**From:** DiMaggio, Janet H - DNR  
**Sent:** Monday, March 26, 2018 2:07 PM  
**To:** Lynn Bradley (lbradley@generalengineering.net)  
**Subject:** Speaker Bid deferral  
**Attachments:** Sspeaker.pdf

**GROUNDWATER ELEVATION CONTOUR & FLOW DIRECTION MAP - JANUARY 18, 2017**  
 Speaker Property & Lutzen Property (Former Kreyer County Store)  
 Town of Mount Ida Grant County, WI

**FIGURE 4**

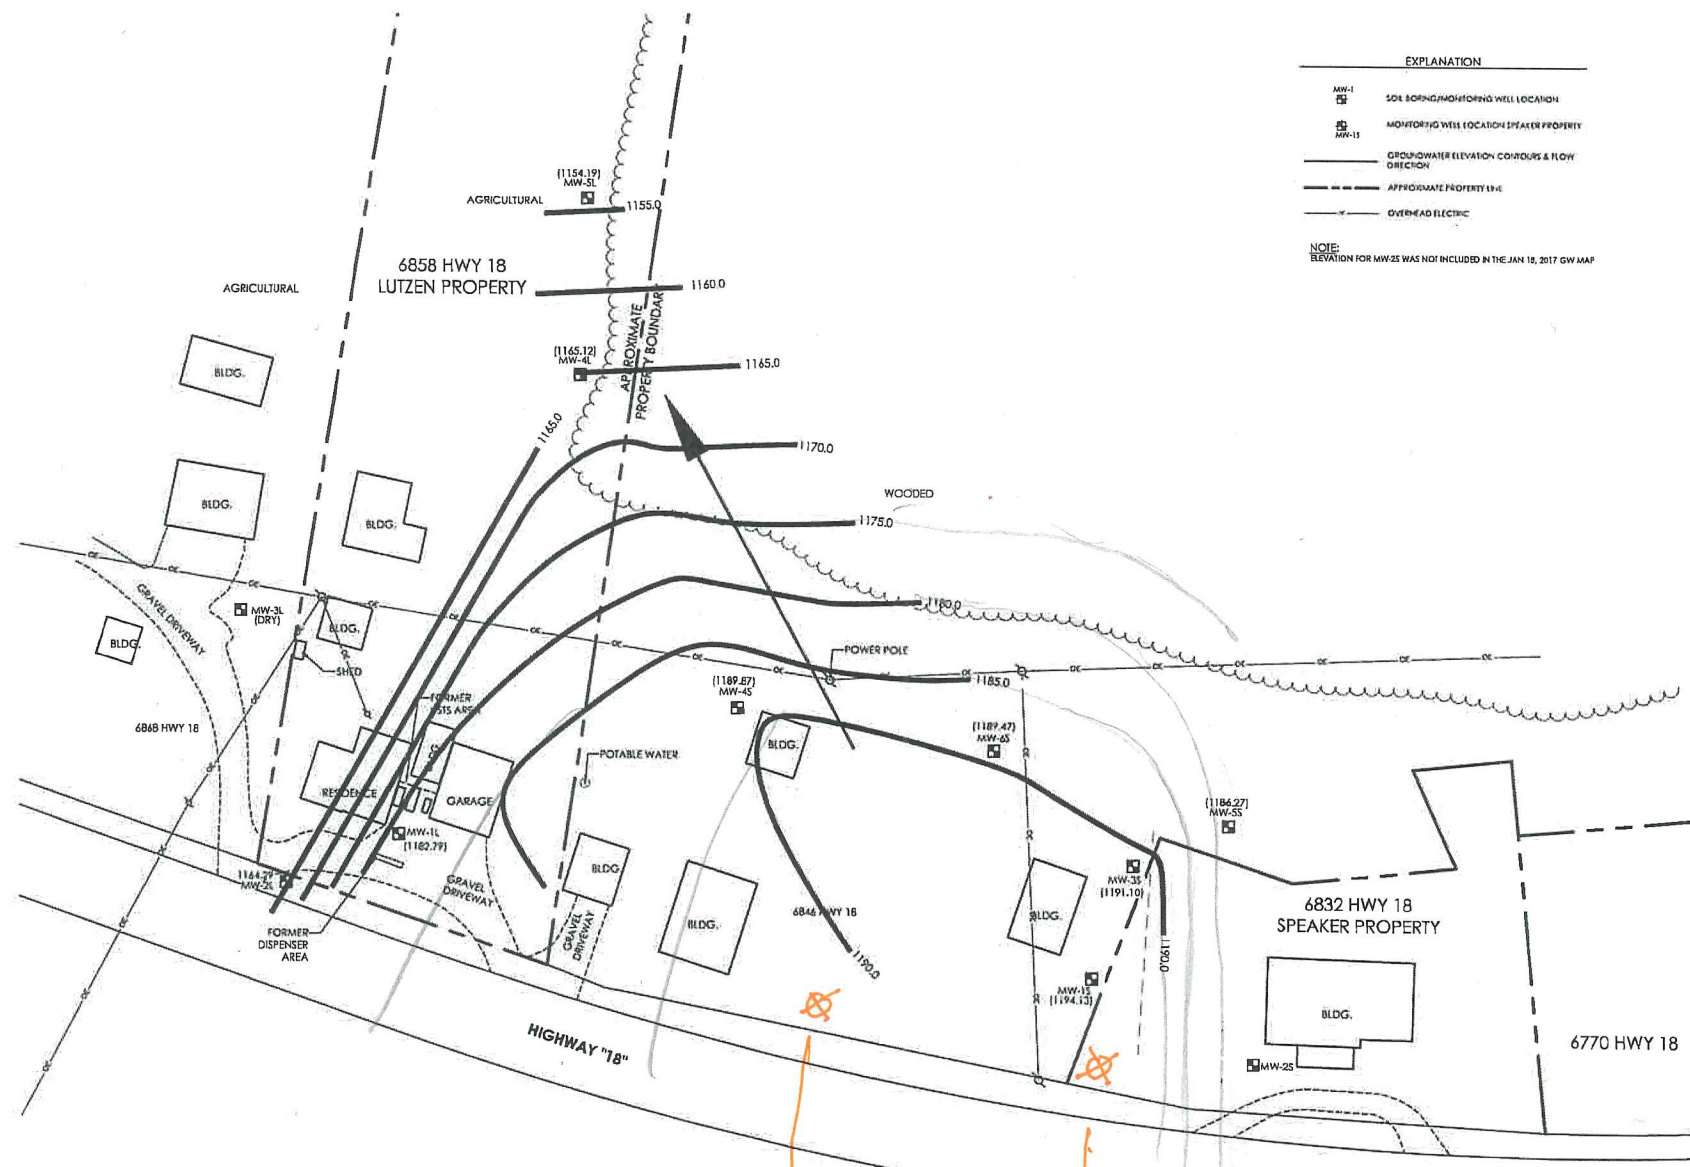
- A second well, MW-8, to be installed west of the proposed MW-7 (see attached map). Please check overhead for locating the well locations.
- Are the homes on private water or municipal? If PWs, I want to see Speaker, Lutzen, and the home in between sampled for gasoline constituents. If on municipal water this is not needed.
- In addition to the aerial photo research on Speaker, I would like to know the property boundaries of the former Town of Ida property on the south side of Hwy 18, the location of ASTs or USTs associated with that property and if, when, how those tanks were closed. If this is not on Sanborns or elsewhere in your files, you might need the aerial photos for this property as well.

I also am curious as to why the water table map, in the February 18 status update, did not use MW-2 to draw contours (see attached for a possibility).

*A second well  
 MW-8*

*Your proposed well  
 MW-7*
